Access Compliance Report

Public Rights-of-Way

(Curb Ramps)

Intersection ID: 11423	Main Street: S_SUMMIT_AV	Cross Street: W_4TH_ST_EXT	Location:	N
ADA ID: D2779C16F697	Ramp Type: Perp	Initial Pass/Fail: Pass	Overall Compliance: No	Severity Score: 0

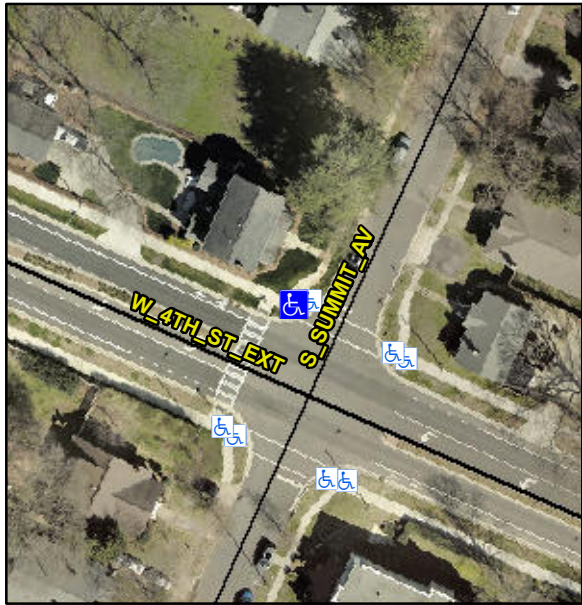
Codes/Mitigation Info/Possible Solution		Field Measurements/Component Compliance								
	Possible Solutions:	Remove & Replace Landing.			Compliance	Description	Data	Compliance	Description	Data
					N/A	Ramp Length (in)	79.0	Yes	Ramp Slope (%)	7.6
					Yes	Ramp Width (in)	70.0	Yes	Ramp XSlope (%)	1.8
					Yes	Flare Type L	Curbed_NoWalkSurface	Yes	Flare Type RT	N/A
					Yes	Flare Slope LT (%)	N/A	N/A	Flare Slope RT (%)	N/A
					N/A	Flare Traversable LT?	No	N/A	Flare Traversable RT?	No
					Yes	Landing Length (in)	71.0	Yes	DWS Provided?	Yes
					Yes	Landing Width (in)	70.0	Yes	DWS Contrast?	Yes
					Yes	Landing Slope (%)	1.0	Yes	DWS Length (in)	24.0
					No	Landing X Slope (%)	3.1	Yes	DWS Full Width?	Yes
				N/A	Landing Curb? (Y/N)	No	Yes	DWS Offset (in)	1.5	
				N/A	Shared Landing?	No				
				Yes	Gutter Ponding?	No	Yes	Gutter Slope (%)	1.1	
				Yes	Gutter Lip Ht (in)	0.0	Yes	Gutter X Slope (%)	2.2	
				N/A	Painted X Walk1?	No	N/A	Painted X Walk2?	N/A
